In the Drawings:

The present communication responds to the Final Action mailed July 6, 2009.

## REMARKS

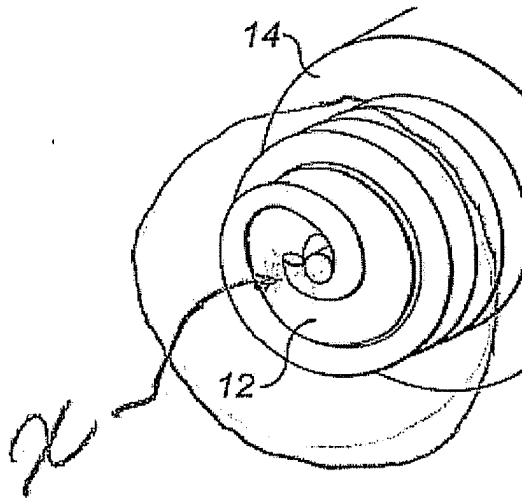
Prior art Figs. 1 and 2 do not disclose the limitation in claim 1 and 32 which reads a single homogeneous insulated wire forms both the coil and the central conductor. The term homogeneous recited in the claims means having a uniform structure. The term single means one. Thus, Applicant's recited claim limitation means that the coil and the conductor form one uniform structure. The prior art does not show a central conductor and coil which forms one uniform structure. The prior art as illustrated below shows two wires. Each wire can be seen below at the "X".

The prior art does not anticipate applicants claim limitation which requires one uniform structure. Accordingly, the rejection to claims 1 and 32 should be withdrawn.

Fig 2.

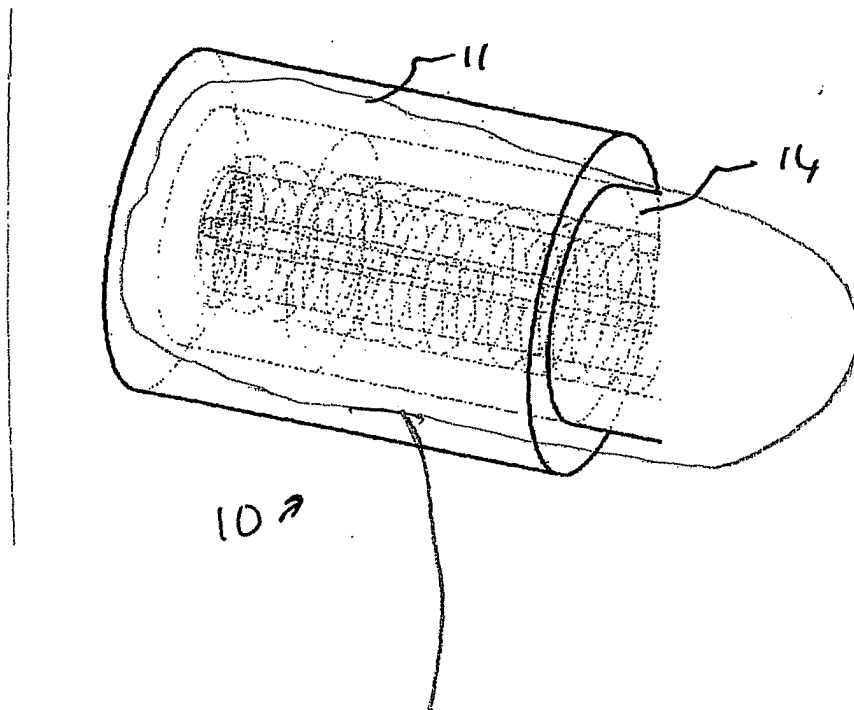
Applicant submits herewith Replacement sheet 1/2. The sheet replaces original sheet 1/4 and 2/4. Figs. 1 and 2 on Replacement Sheet 1/2 were labeled prior art. Reference numbers 18, 10 and 16 have been removed from Fig. 1. Reference number 10 has been removed from Fig. 2. Additionally, the coiling and internal structure shown in original Fig. 2 has been clarified. A marked sheet showing where the coiling and internal structure has been clarified, is attached to the action.

item clarified
